Step-3 Report on
784 Memorial Drive

Includes a Calculation and Assessment of Queues,
as well as Traffic Mitigation Proposals and
Signal Warrant Study Results

prepared by Stephen H. Kaiser
191 Hamilton Street
Cambridge, Mass. 02139

February 25, 1999

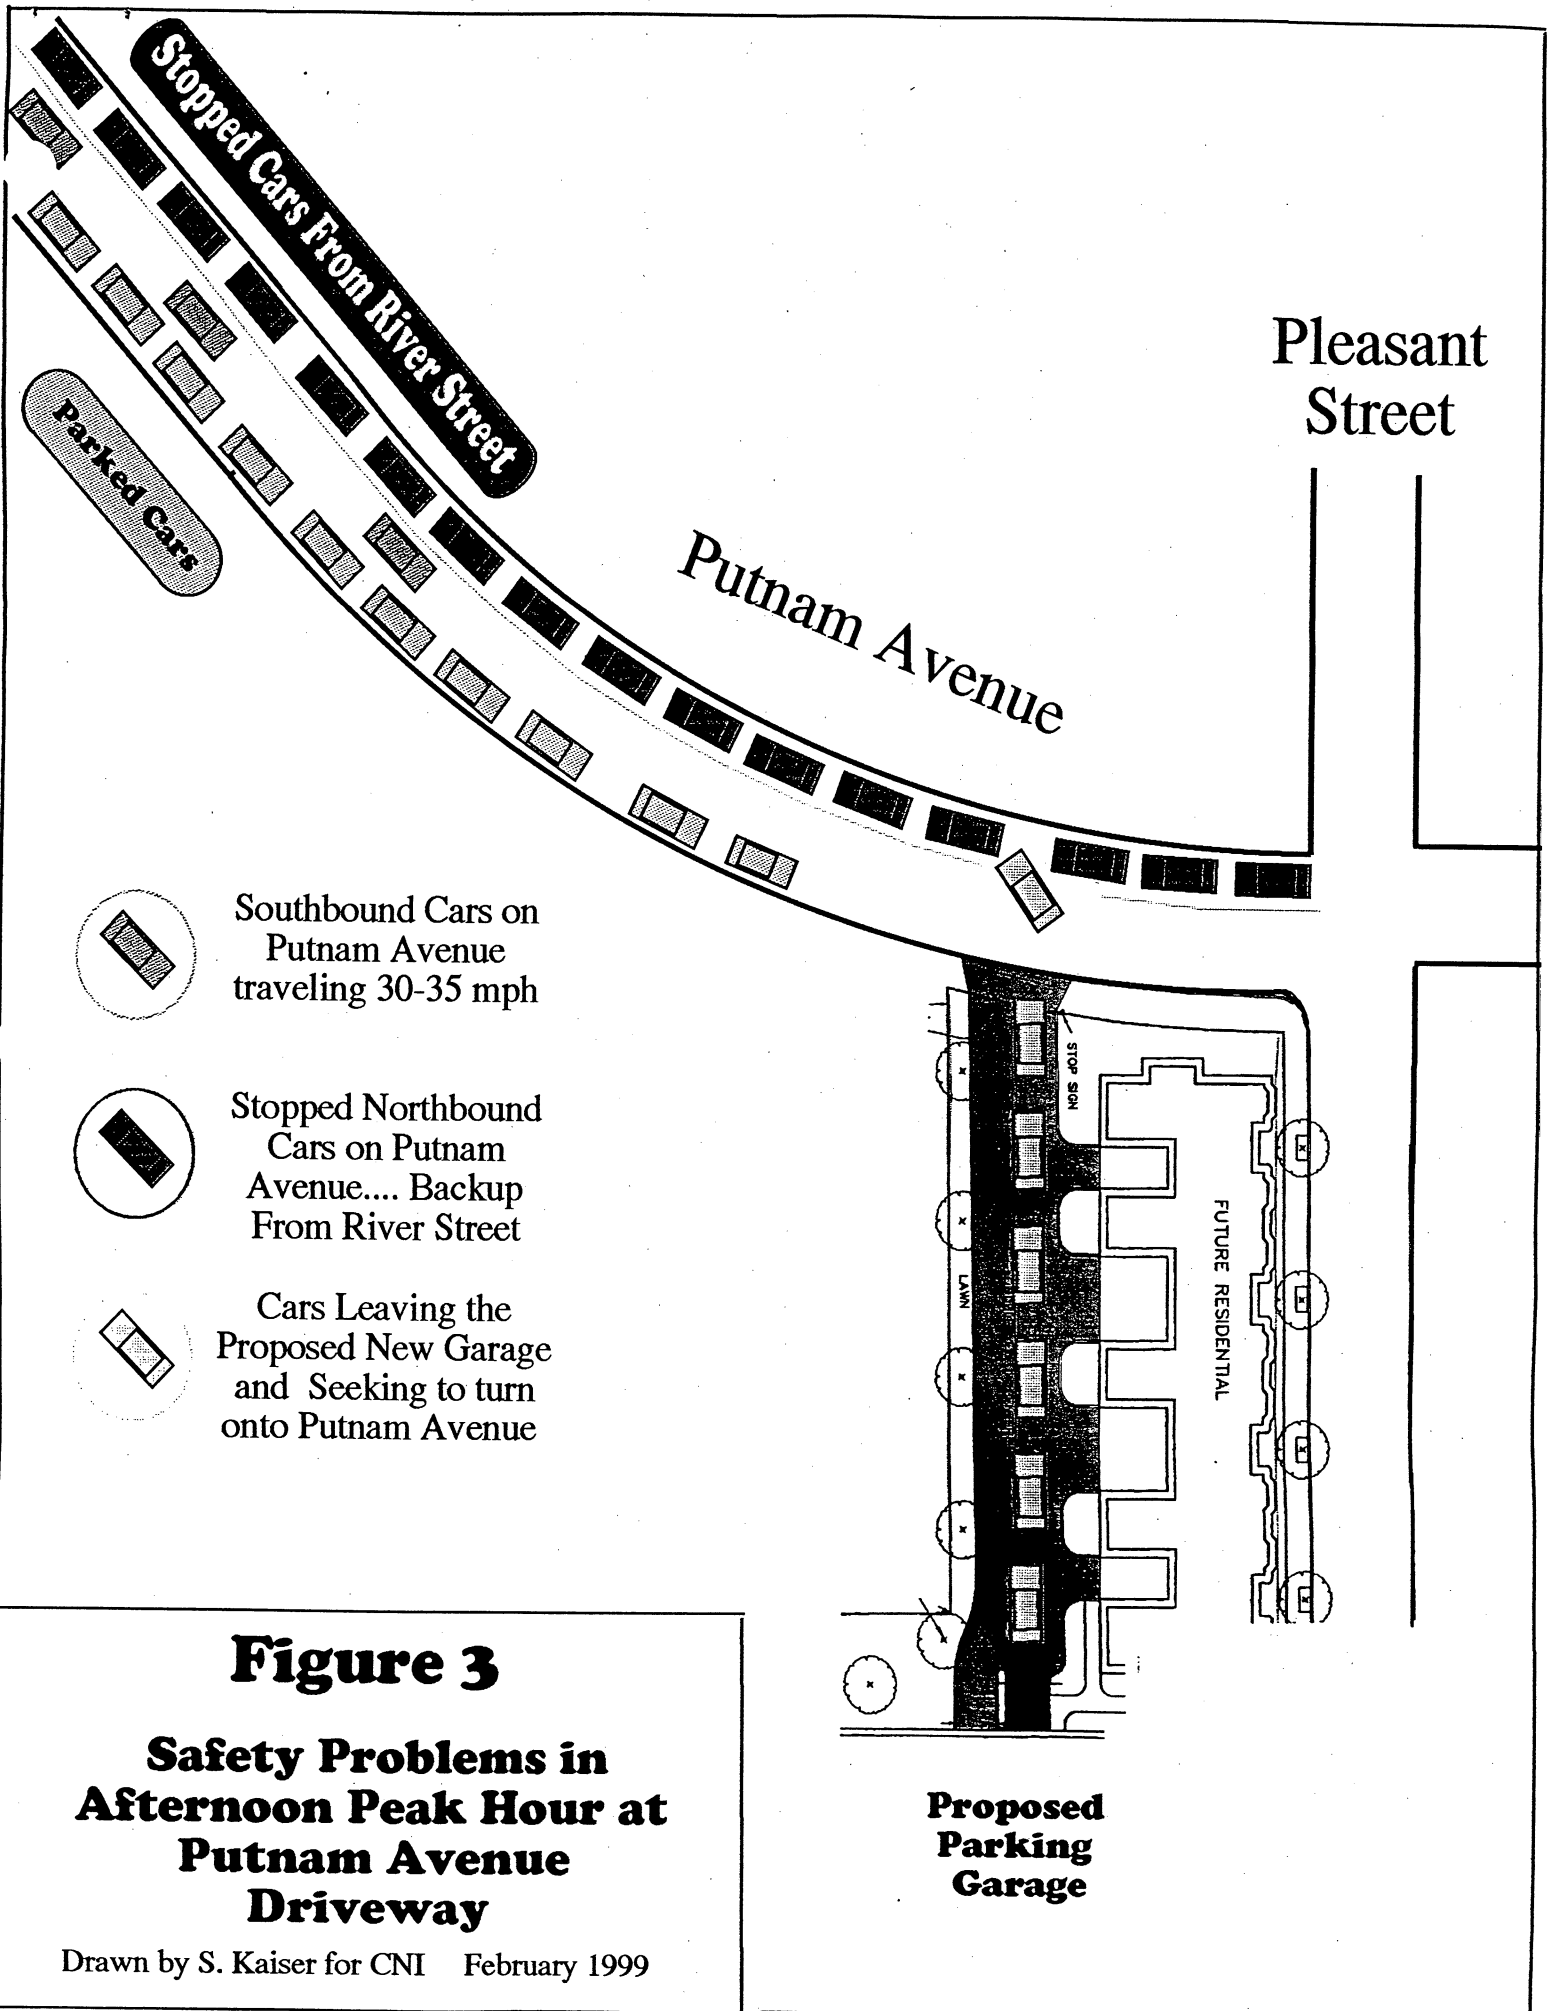
The current proposal for the relocation of two driveways would result in a vast improvement on Pleasant Street -- compared to the extremely awkward -- indeed scandalous -- design for the intersection which is inherent in the single driveway plan associated with the February 1998 building permit for the garage. The simple T-intersection on Pleasant Street would be closer to Memorial Drive, less likely to direct traffic onto the neighborhood and avoids dangerous hairpin turns.

Unfortunately, the shifting of the Putnam Avenue driveway does not deserve the City's redesignation of an "unsafe" driveway into a "safe" one. There is a problem of visibility for drivers coming out of the Putnam Avenue driveway during the afternoon peak hour, with a line of backed-up cars on Putnam Avenue obscuring a clear view of on-coming cars.

In addition, the queue will not provide easy gaps for exiting cars to get into. These drivers will need to do some "butting in." This action will likely cause some stopped cars to occupy part of the southbound lane of Putnam Avenue -- using a fairly common "Boston driver" practice as shown in Figure 3. There is a more severe visibility problem for drivers traveling south -- because the line of queued cars obstructs the view of any car which is partially blocking the lane. With southbound cars on Putnam Avenue traveling at 30-35 mph, there might not be sufficient time to stop, especially in conditions of inclement weather.

FIGURE 1 Existing Problem Areas

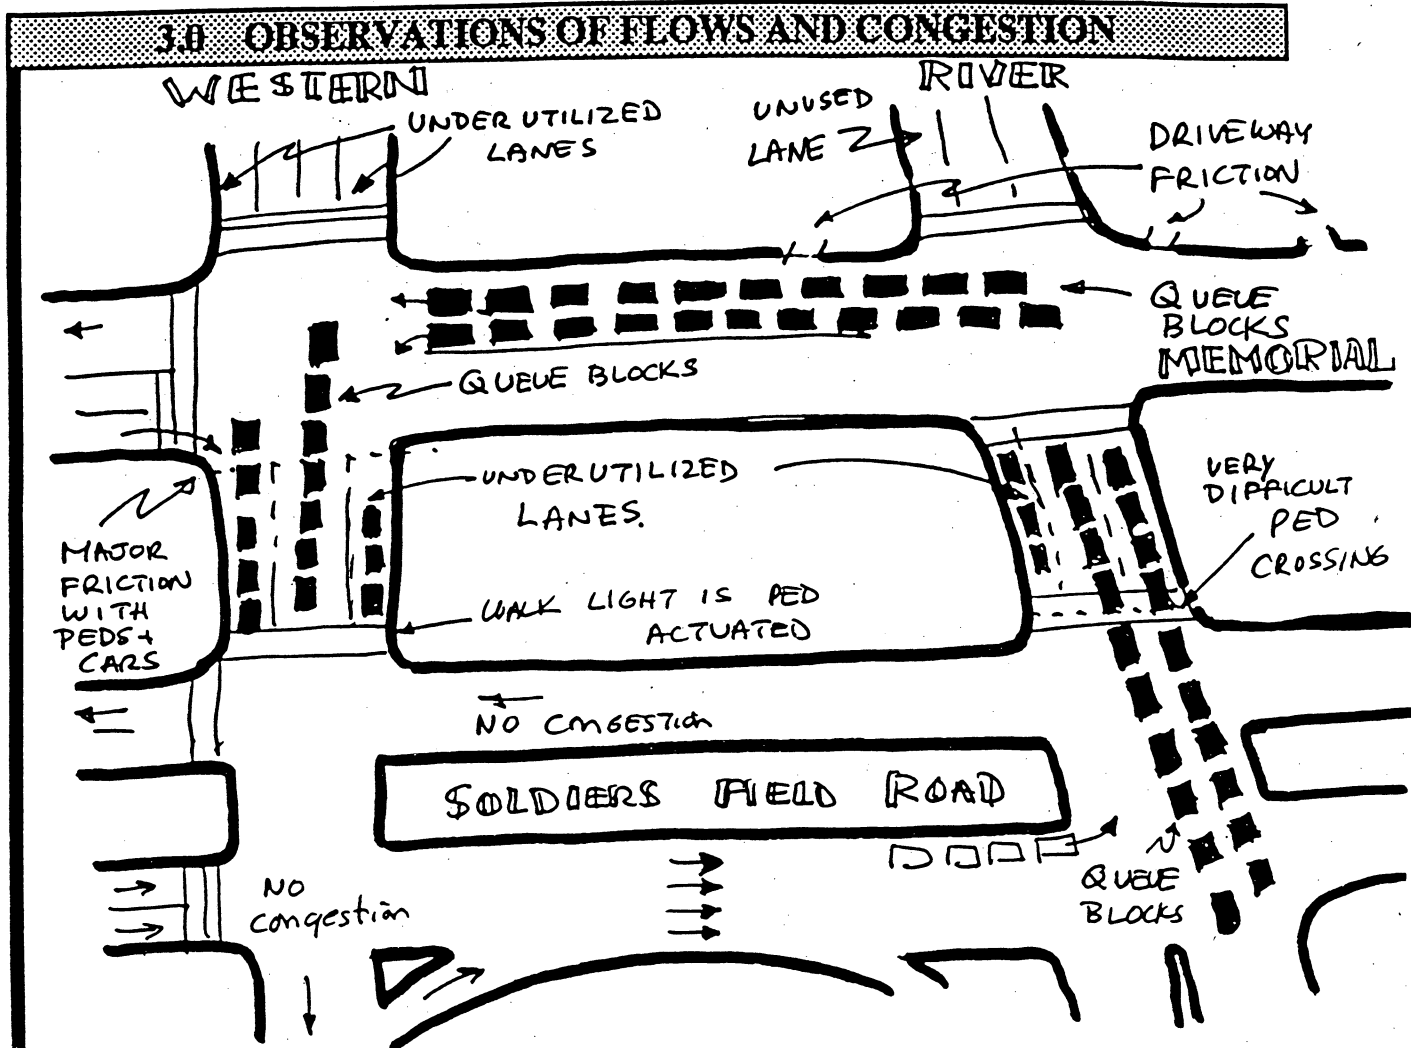
CNI made afternoon peak hour observations and counts in September 1997. (Congestion in the morning occurs primarily on Western Avenue -- due to inefficient signal timing -- and on the Boston side of the river at the Turnpike exit.) Of the four locations under discussion, brief gridlock blockage occurred at three of the four intersections. The one intersection which is below capacity is the new location #1 at Soldiers Field Road and Western Avenue. Generally, all approaching traffic flushes easily on the inbound exit ramp and the outbound service road. There are three queues which can cause intersection blockage :

FIGURE 2
MEMORIAL DRIVE OUTBOUND, Sept.3, 1997
 5:30 PM Average of Both Lanes

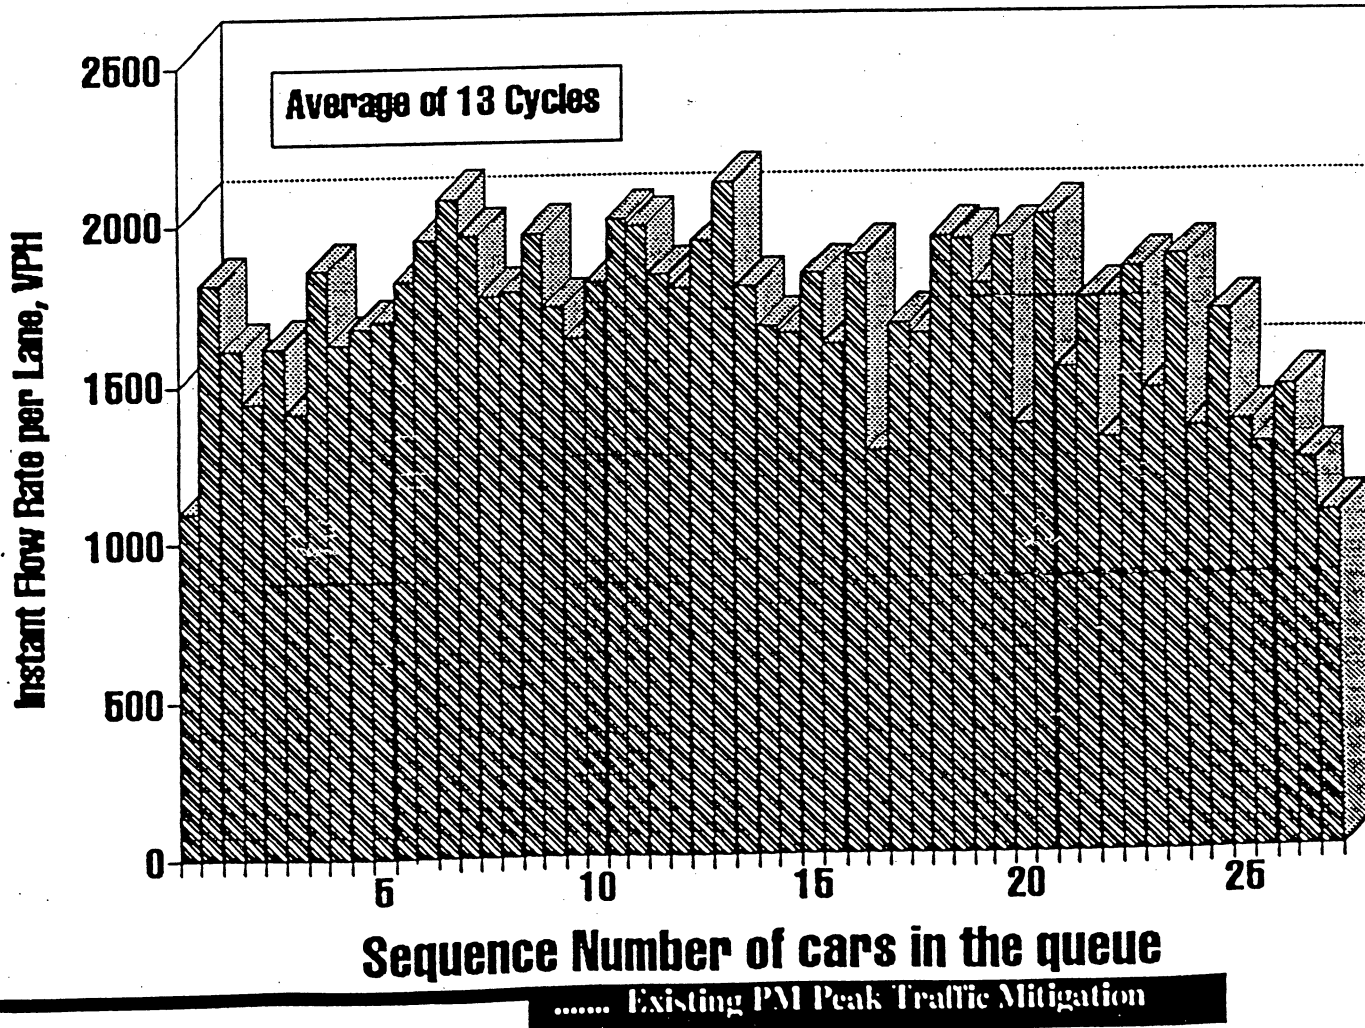
Figure 2 illustrates the average flow rates of each car in a queue over 13 cycles. We can see the lost time as the first car starts up, as well as the peak flow about the 15th car with a drop in flow rate for later cars in the queue, especially #25 to #28. These results are very sobering because they show the optimum phase length is 15 to 25 seconds (7 to 13 cars) in contrast to the long phase of 58 seconds now in effect. We can see clearly that capacity can be enhanced by making cycle times *shorter*, not longer as almost all traffic engineers presume today. Such a perspective represents a dramatic reversal in the traditional traffic engineering thinking about optimizing traffic signal timing – and also applies to the City of Cambridge and other entities using long signal cycle lengths.

FIGURE 3 Soldiers Field Road and Western Avenue

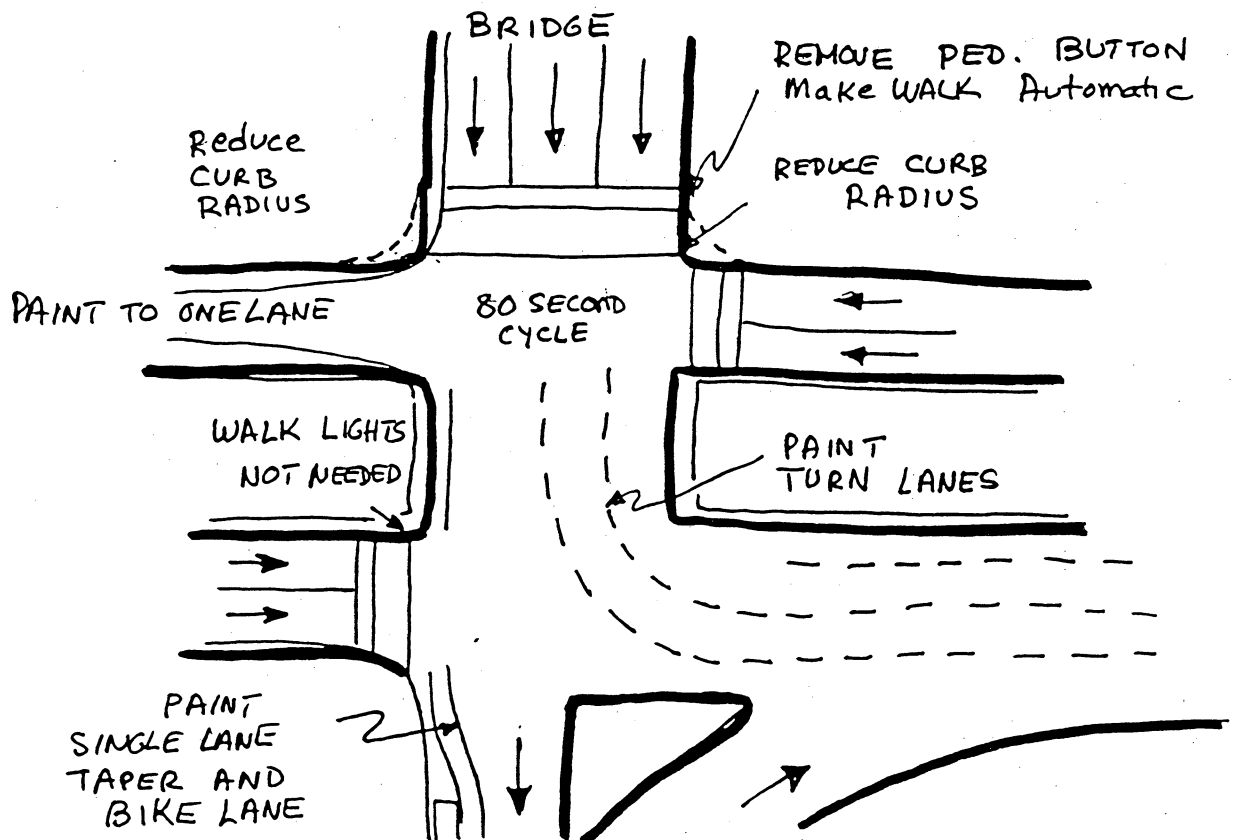
A few years ago the Western Avenue bridge was repainted from four narrow lanes down to three wide ones. The capacity and storage provided by three lanes appear adequate, and there does appear to be sufficient room to pull the right edge line out a few feet to create a small shoulder/bike lane.

Another change would be to paint left turn guidance lines from the bridge onto the Soldiers Field inbound service road, so that vehicles on the inside would have an easier time turning with less squeezing by cars on the right in the middle lane. The intent is to increase the flow and utilization of the left-most lane on the bridge with resulting improved efficiency.

The pedestrian WALK lights here are the only ones at the four locations, but they simply provide for concurrent movements. If the Charles River path user does not push the button, there is no WALK indication even though the Western Avenue traffic is stopped on the bridge for 60 seconds out of every 100. The need to push a button here is patently absurd : it should come on automatically and the pushbutton should be deleted. There is no sacrifice in traffic movement to allow this and everything to be gained for the upgrading of a street crossing on the MDC path for pedestrians, joggers, bicyclists, roller bladers, and wheelchairs.

FIGURE 4 Memorial Drive and Western Avenue

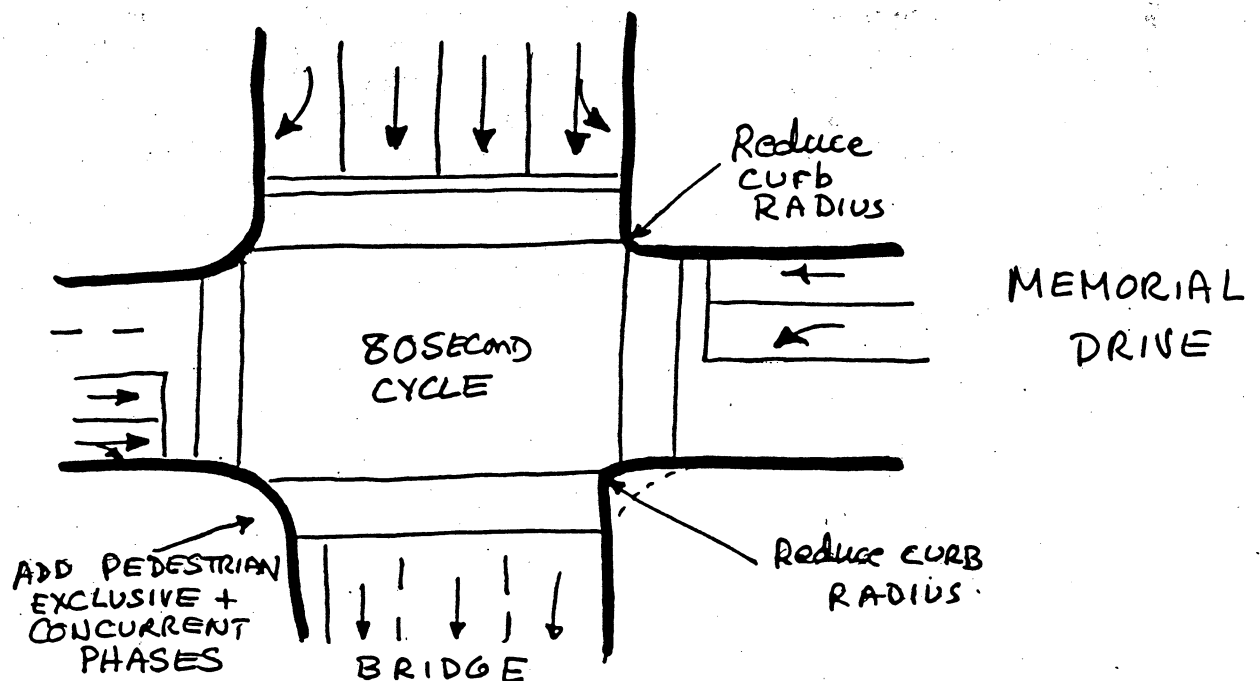
The approach on Western Avenue appears to be four lanes, but the right lane is basically for right turns only and is lightly used by about 5 cars per cycle, while the left lane includes 6 left turns and numerous through vehicles. The left lane is a short lane that extends only to Blackstone Street and many drivers prefer to remain in the center lanes rather than change lanes. Shorter cycle times would result in better utilization of this left lane.

FIGURE 5 MEMORIAL DRIVE AND RIVER STREET

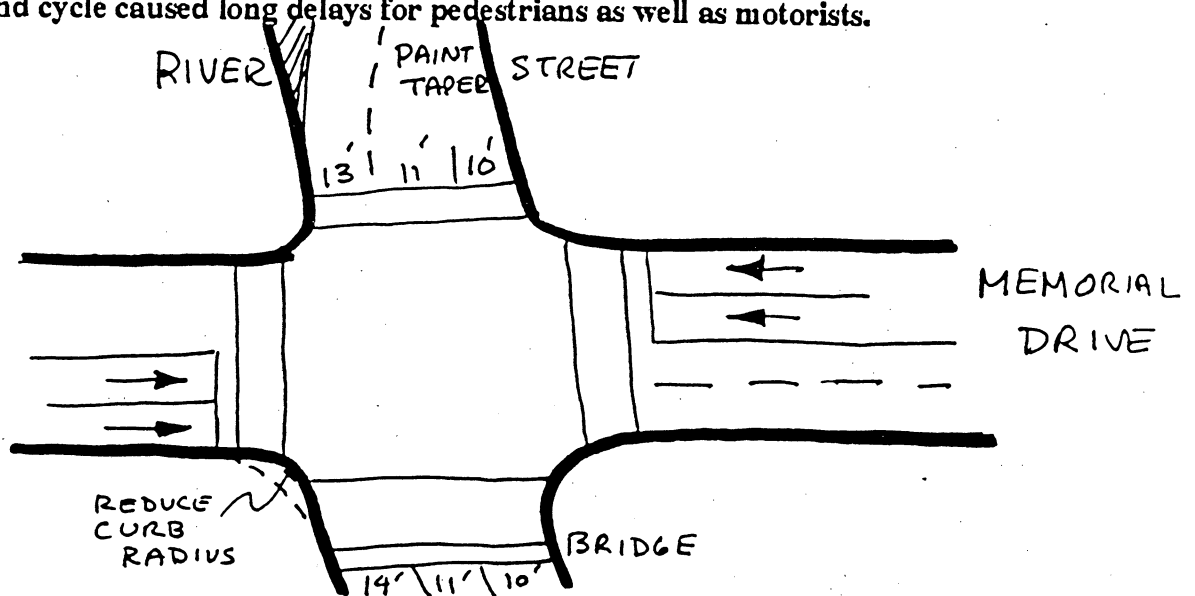
1. Queues which back up from Western Avenue into River Street
2. The same queues may affect left turns from the River Street Bridge
3. There is minimal use of the left lane on the bridge and partial use of the center lane.
4. At the end of the bridge green phase, there is often vast amount of empty time when no traffic moves.
5. There is restricted flow in the right hand lane off the bridge because of friction with pedestrians
6. Some traffic interference does occur at three driveways to gas stations along the north side of Memorial Drive.

The good news is that some of this waste time is being used for pedestrian crossings, and River Street does stop completely for almost 70 seconds -- although the 140-second cycle caused long delays for pedestrians as well as motorists.

A detailed analysis of 13 signal cycles demonstrated that shifting from the existing 140-second cycle to an 80-second cycle would result in higher capacity, with a net time savings of 3 seconds on the outbound phase.
